**STATEMENT OF  
ENVIRONMENTAL EFFECTS  
(Incorporating a Site Analysis)**

**CLAUSE 4.55 AMENDED DEVELOPMENT APPLICATION**

**PROPOSED DEMOLITION OF EXISTING DWELLING AND  
CONSTRUCTION OF DUAL OCCUPANCY (DUPLEX) AND  
TORRENS TITLE SUBDIVISION.**

**Address:** LOT 22 DP.236764 11 HARDEN CRES GEORGES HALL

## 6. PROPOSED MODIFICATIONS

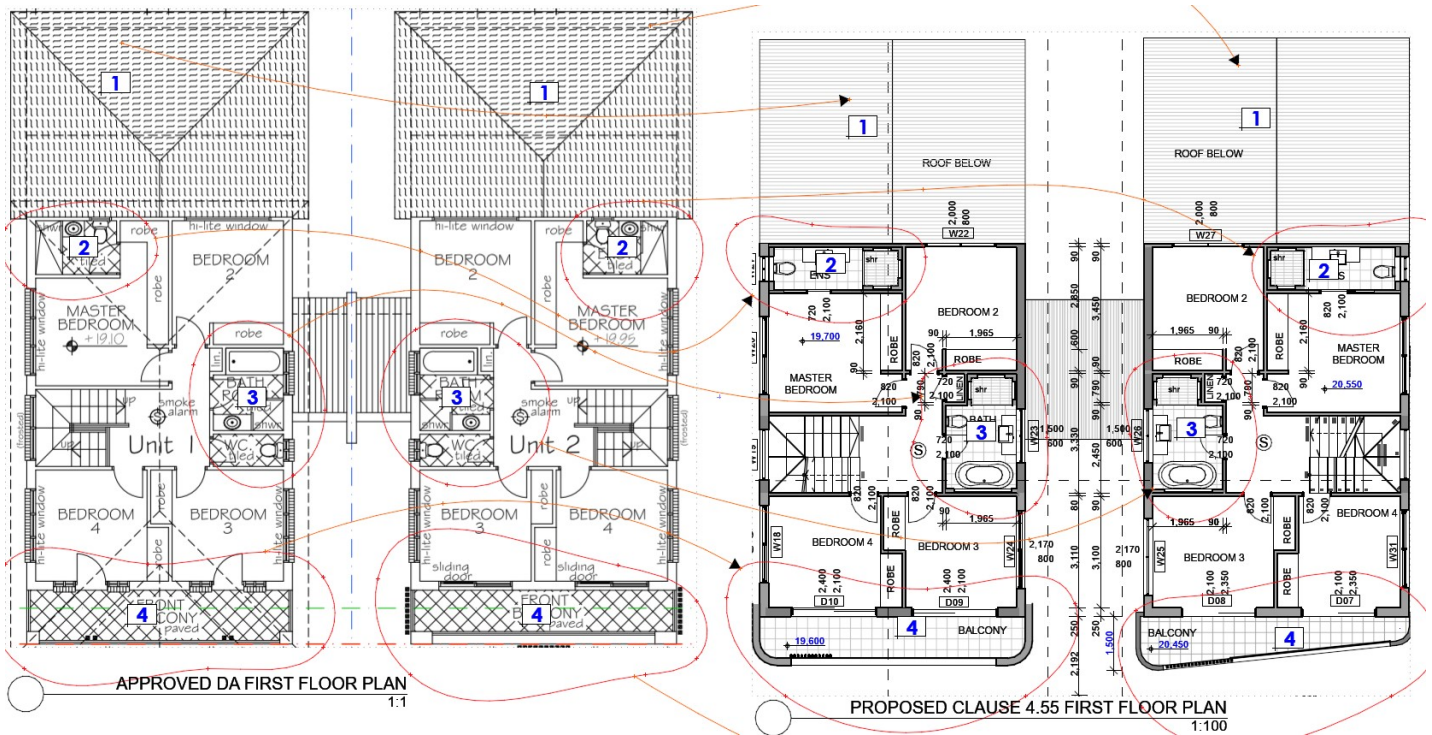
1. LOWER ROOF TO ALFRESCO CHANGE TO METAL ROOF WITH GABLE
2. MASTER BEDROOM ENSUITE REVISED LAYOUT AND SIZE, WINDOW RELOCATED
3. BATHROOMS REVISED LAYOUT, WINDOW RELOCATED

4. FRONT 1ST FLOOR BALCONY PROFILE AMENDED TO SUIT FACADE CHARACTER
5. LOWER ROOF TO ALFRESCO CHANGE TO METAL ROOF WITH GABLE
6. MASTER BEDROOM ENSUITE REVISED LAYOUT AND SIZE, WINDOW

7. RELOCATED BATHROOMS REVISED LAYOUT, WINDOW RELOCATED
8. FRONT 1ST FLOOR BALCONY PROFILE AMENDED TO SUIT FACADE CHARACTER
9. UNIT 1 ROOF CHANGE TO METAL ROOF 8 DEGREE SLOPE INSTEAD OF 25 DEGREES GABLE REMOVED AND REPLACED WITH PARAPET WALL TO CONCEAL ROOF.

10. UNIT 1 AND 2 FACADE ARCHITECTURE CHANGED
11. UNIT 1 AND 2 FRONT LIVING WINDOW AMENDED
12. UNIT 1 AND 2 FIRST FLOOR CEILING HIEGHT INCREASED TO 2.75M INSTEAD OF 2.4M

13. RIDGE AND PARAPET ROOF RL LEVEL AMENDED
14. UNIT 1 AND 2 ENSUITE WINDOW RELOCATED FROM REAR WALL TO SIDE WALL
15. UNIT 1 AND 2 BEDROOM 2 REAR WINDOW WIDTH REDUCED

16. UNIT 1 AND 2 ALFRESCO ROOF CHANGED TO GABLE ROOF AND METAL CLADDING
17. UNIT 1 AND 2 FIRST FLOOR ROOF LOWERED SLOPE TO 8 DEGREES AND MADE GABLE END
18. UNIT 1 AND 2 FIRST FLOOR CEILING HIEGHT INCREASED TO 2.75M INSTEAD OF 2.4M

19. RIDGE PARAPET RL LEVEL AMENDED
20. UNIT 1 AND 2 STAIR SIDE WINDOW INCREASED HIEGHT
21. UNIT 1 AND 2 FIRST FLOOR BALCONY AND FACADE REDESIGN AND UPGRADE

22. UNIT 1 AND 2 FIRST FLOOR ROOF LOWERED SLOPE TO 8 DEGREES AND MADE GABLE END
23. UNIT 1 AND 2 STAIR SIDE WINDOW REDUCED HIEGHT
24. UNIT 1 AND 2 SIDE BEDROOM WIDOW REDUCED WIDTH

25. UNIT 1 AND 2 ALFRESCO ROOF CHANGED TO GABLE
- 26.

#### CLAUSE 4.55 AMENDMENTS

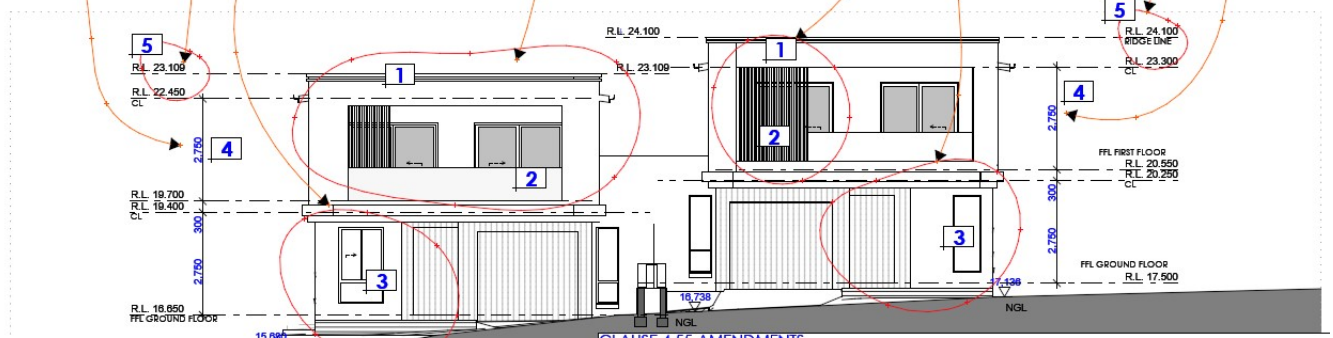
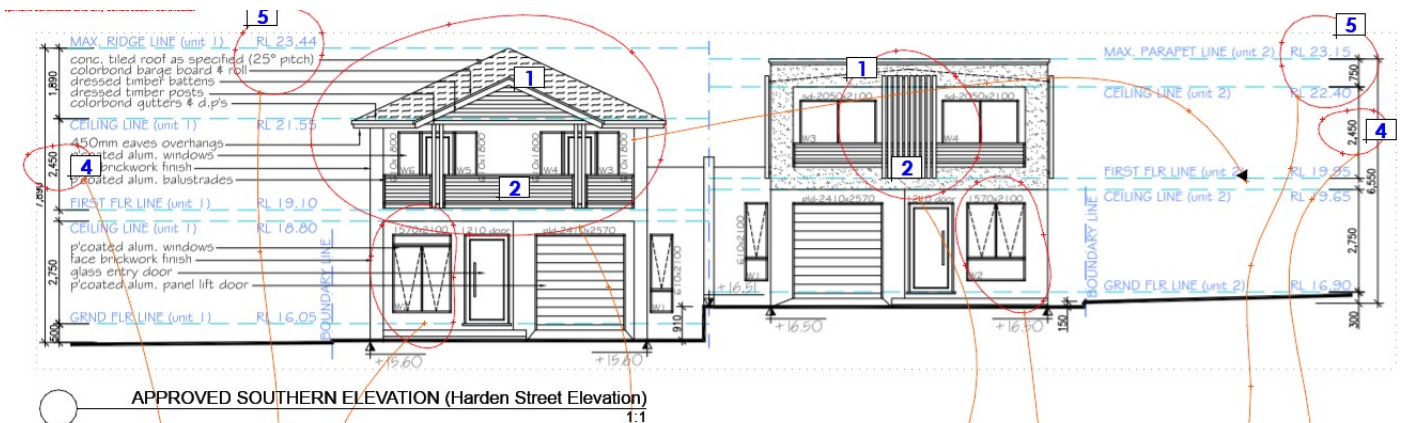
1. LOWER ROOF TO ALFRESCO CHANGE TO METAL ROOF WITH GABLE
2. MASTER BEDROOM ENSUITE REVISED LAYOUT AND SIZE, WINDOW RELOCATED
3. BATHROOMS REVISED LAYOUT, WINDOW RELOCATED
4. FRONT 1ST FLOOR BALCONY PROFILE AMENDED TO SUIT FACADE CHARACTER

#### CLAUSE 4.55 AMENDMENTS

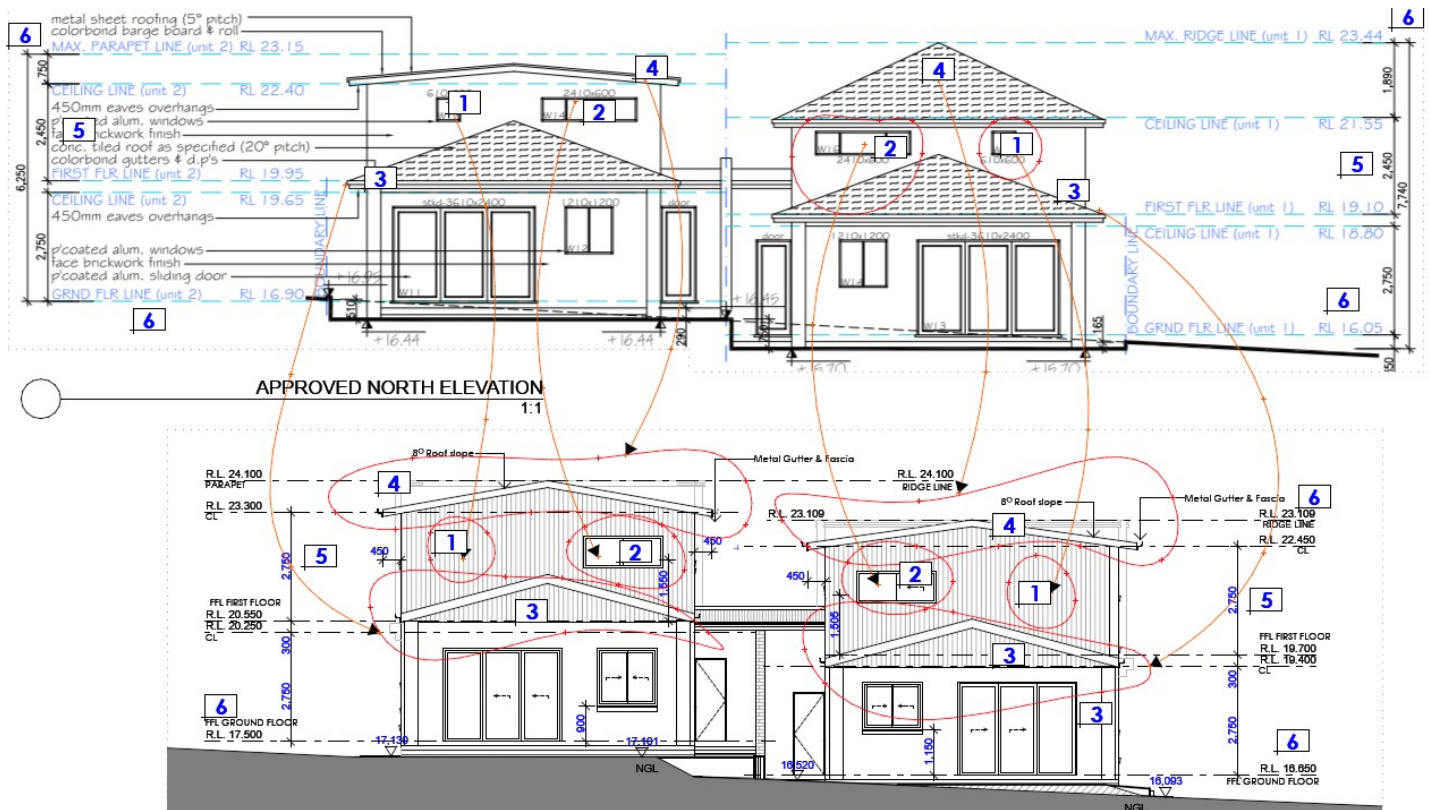
1. UNIT 1 ROOF CHANGE TO METAL ROOF 8 DEGREE SLOPE INSTEAD OF 25 DEGREES GABLE REMOVED AND REPLACED WITH PARAPET WALL TO CONCEAL ROOF.
2. UNIT 1 AND 2 FACADE ARCHITECTURE CHANGED
3. UNIT 1 AND 2 FRONT LIVING WINDOW AMENDED
4. UNIT 1 AND 2 FIRST FLOOR CEILING HEIGHT INCREASED TO 2.75M INSTEAD OF 2.4M
5. RIDGE AND PARAPET ROOF RL LEVEL AMENDED

#### CLAUSE 4.55 AMENDMENTS

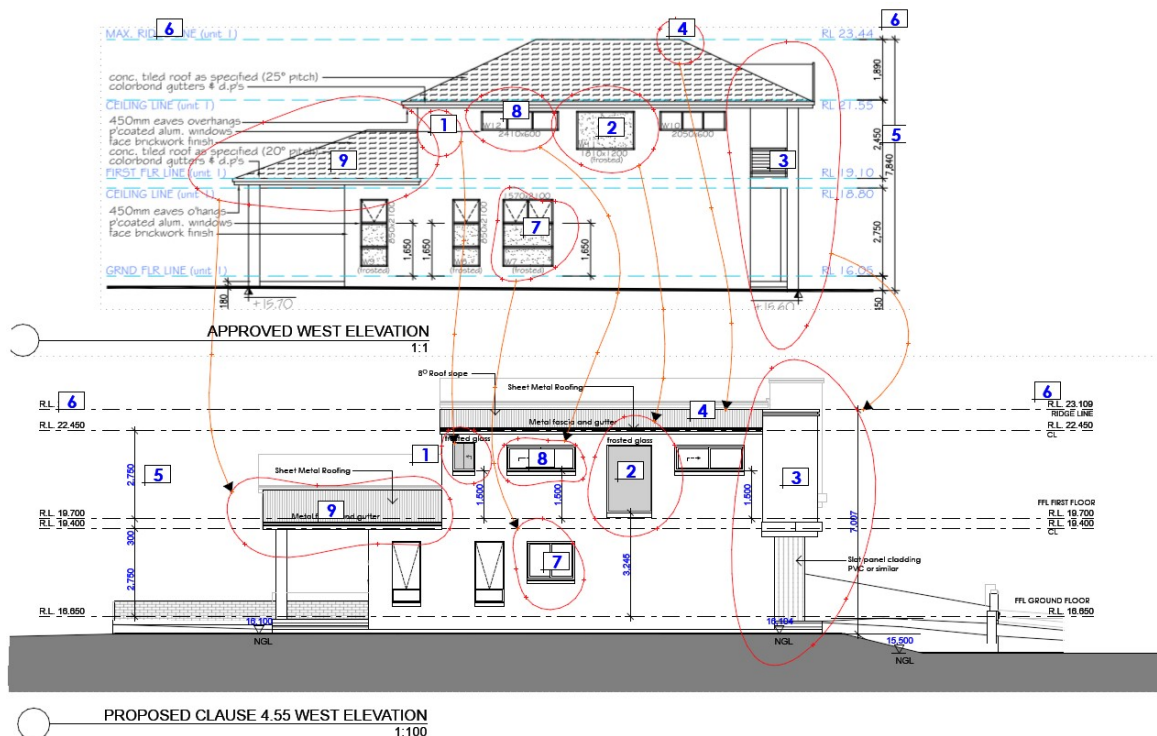
1. UNIT 1 AND 2 ENSUITE WINDOW RELOCATED FROM REAR WALL TO SIDE WALL
2. UNIT 1 AND 2 BEDROOM 2 REAR WINDOW WIDTH REDUCED
3. UNIT 1 AND 2 ALFRESCO ROOF CHANGED TO GABLE ROOF AND METAL CLADDING
4. UNIT 1 AND 2 FIRST FLOOR ROOF LOWERED SLOPE TO 8 DEGREES AND MADE GABLE END
5. UNIT 1 AND 2 FIRST FLOOR CEILING HEIGHT INCREASED TO 2.75M INSTEAD OF 2.4M
6. RIDGE PARAPET RL LEVEL AMENDED

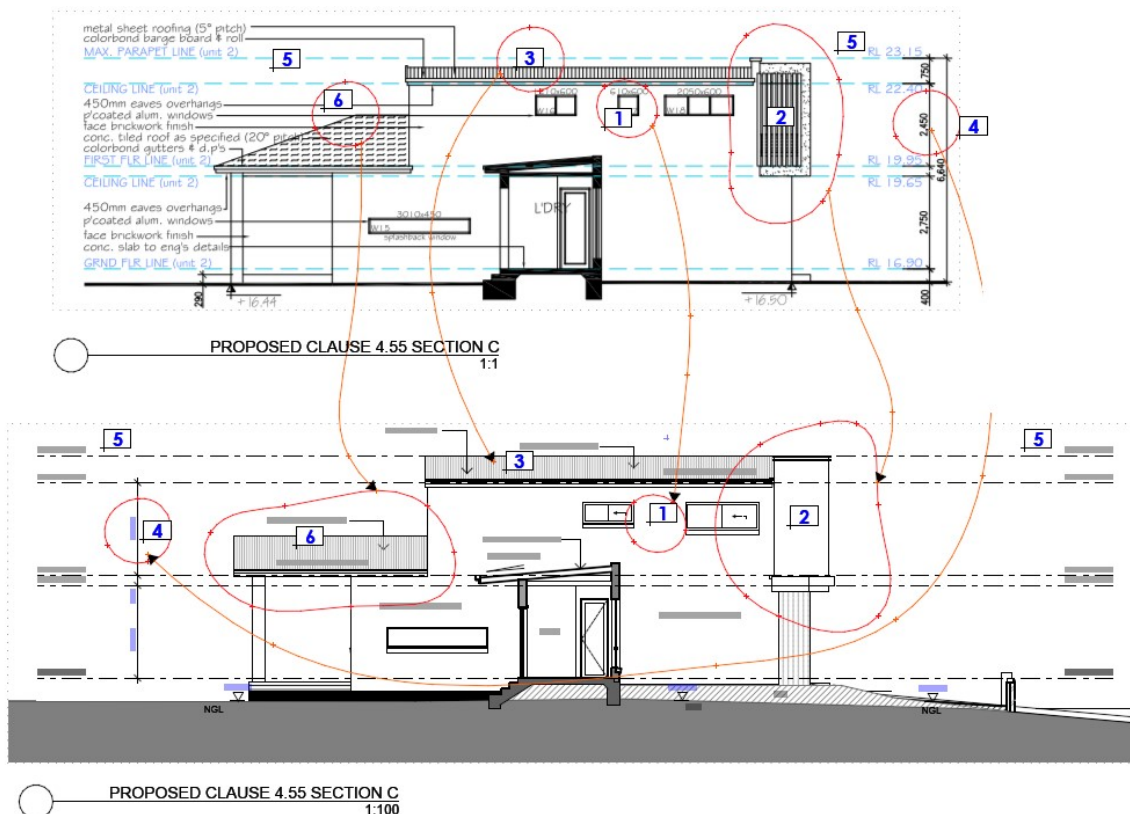
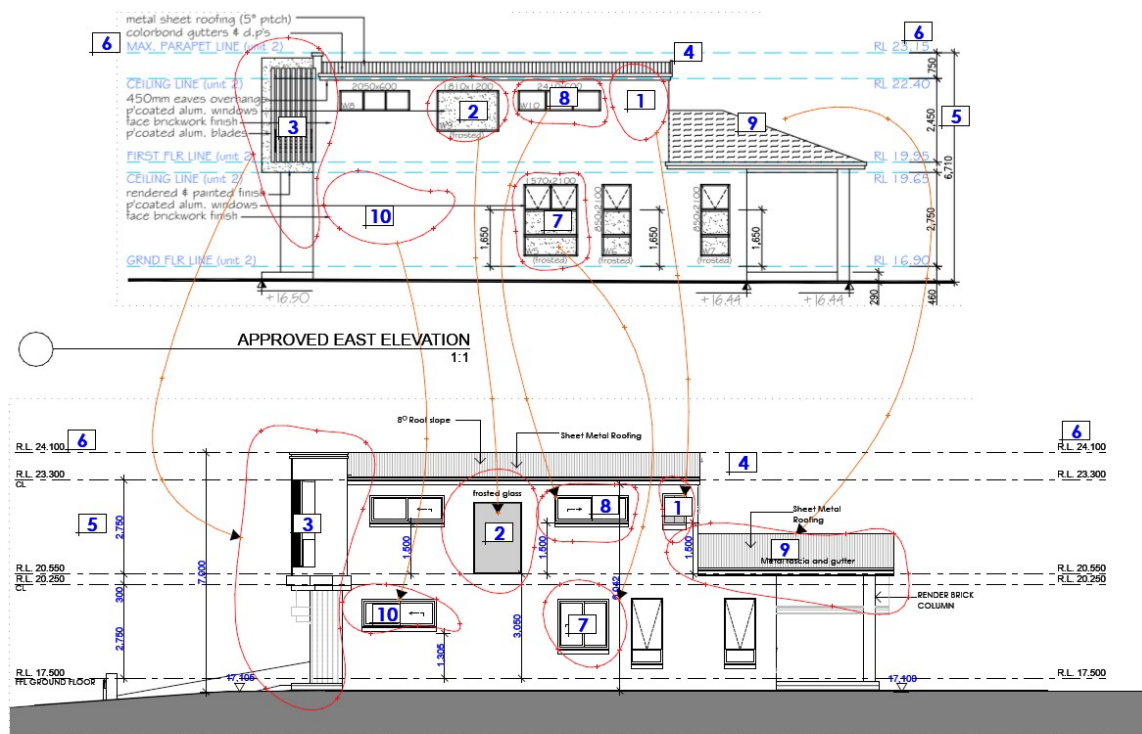
- CLAUSE 4.55 AMENDMENTS**
1. UNIT 1 AND 2 ENSUITE WINDOW RELOCATED FROM REAR WALL TO SIDE WALL
  2. UNIT 1 AND 2 STAIR SIDE WINDOW INCREASED HEIGHT
  3. UNIT 1 AND 2 FIRST FLOOR BALCONY AND FACADE REDESIGN AND UPGRADE
  4. UNIT 1 AND 2 FIRST FLOOR ROOF LOWERED SLOPE TO 8 DEGREES AND MADE GABLE END
  5. UNIT 1 AND 2 FIRST FLOOR CEILING HEIGHT INCREASED TO 2.75M INSTEAD OF 2.4M
  6. RIDGE PARAPET RL LEVEL AMENDED
  7. UNIT 1 AND 2 STAIR SIDE WINDOW REDUCED HEIGHT
  8. UNIT 1 AND 2 SIDE BEDROOM WINDOW REDUCED WIDTH
  9. UNIT 1 AND 2 ALFRESCO ROOF CHANGED TO GABLE

#### CLAUSE 4.55 AMENDMENTS

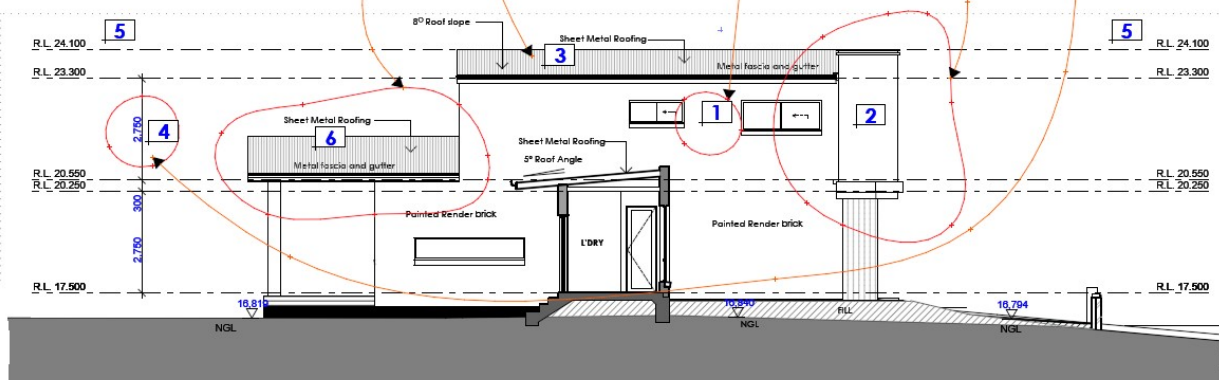
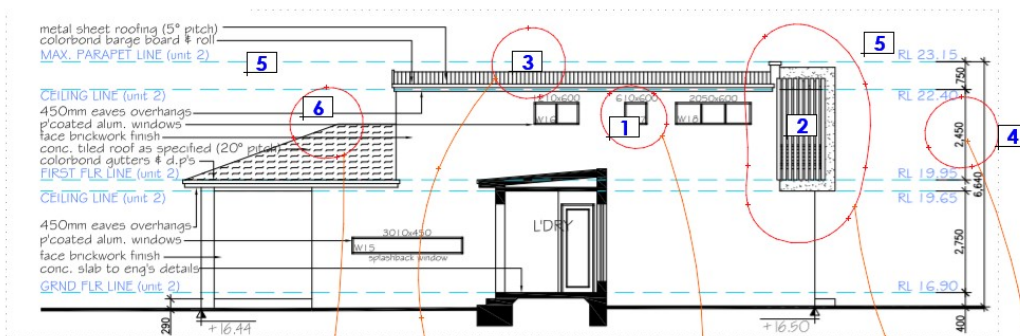
1. UNIT 1 AND 2 ENSUITE WINDOW RELOCATED FROM REAR WALL TO SIDE WALL
2. UNIT 1 AND 2 STAIR SIDE WINDOW INCREASED HEIGHT
3. UNIT 1 AND 2 FIRST FLOOR BALCONY AND FACADE REDESIGN AND UPGRADE
4. UNIT 1 AND 2 FIRST FLOOR ROOF LOWERED SLOPE TO 8 DEGREES AND MADE GABLE END
5. UNIT 1 AND 2 FIRST FLOOR CEILING HEIGHT INCREASED TO 2.75M INSTEAD OF 2.4M
6. RIDGE PARAPET RL LEVEL AMENDED
7. UNIT 1 AND 2 STAIR SIDE WINDOW REDUCED HEIGHT
8. UNIT 1 AND 2 SIDE BEDROOM WINDOW REDUCED WIDTH
9. UNIT 1 AND 2 ALFRESCO ROOF CHANGED TO GABLE

# CLAUSE 4.55 AMENDMENTS

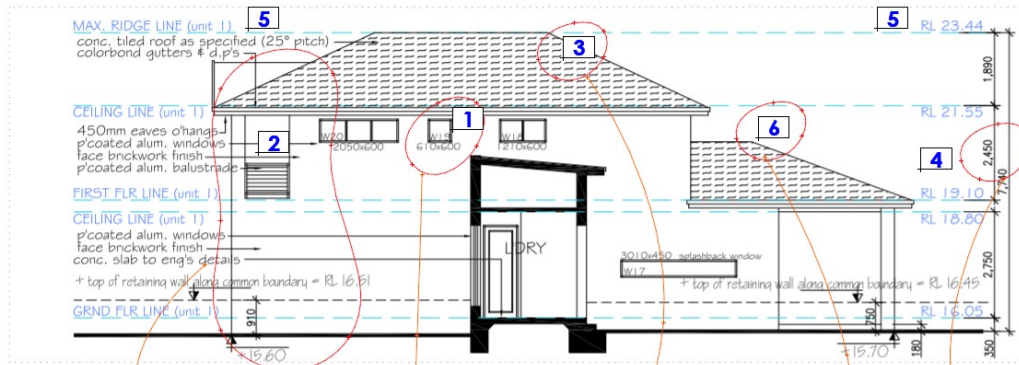
1. UNIT 1 AND 2 WC WINDOW REMOVED
2. UNIT 1 AND 2 FIRST FLOOR BALCONY AND FACADE REDESIGN AND UPGRADE
3. UNIT 1 AND 2 FIRST FLOOR ROOF LOWERED SLOPE TO 8 DEGREES AND MADE GABLE END
4. UNIT 1 AND 2 FIRST FLOOR CEILING HEIGHT INCREASED TO 2.75M INSTEAD OF 2.4M
5. RIDGE PARAPET RL LEVEL AMENDED
6. UNIT 1 AND 2 ALFRESCO ROOF CHANGED TO GABLE

PROPOSED CLAUSE 4.55 FRONT FENCE ELEVATION  
1:100

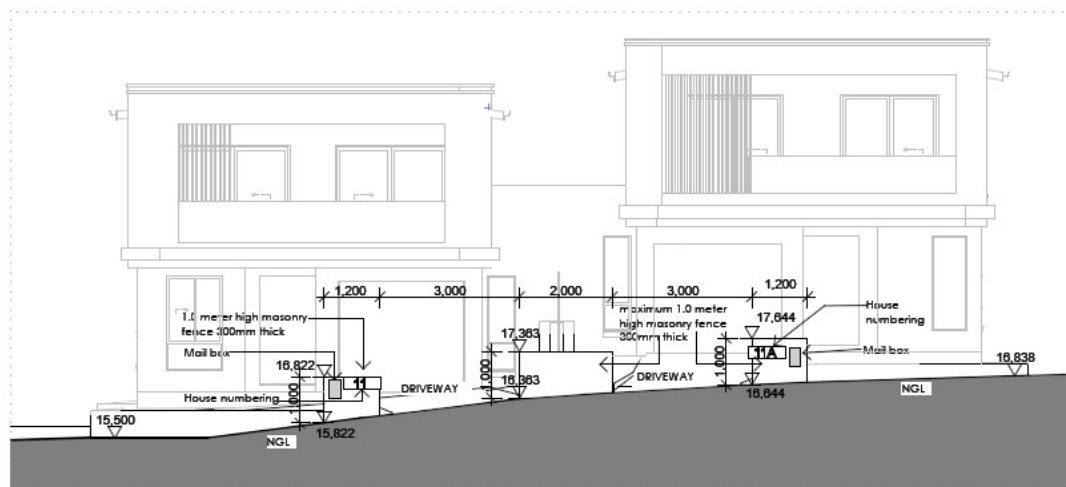
Front fence is proposed to be reduced with 1.0 meter high concrete fence centre boundary location as well as postal box and house number clearly visible from the street.
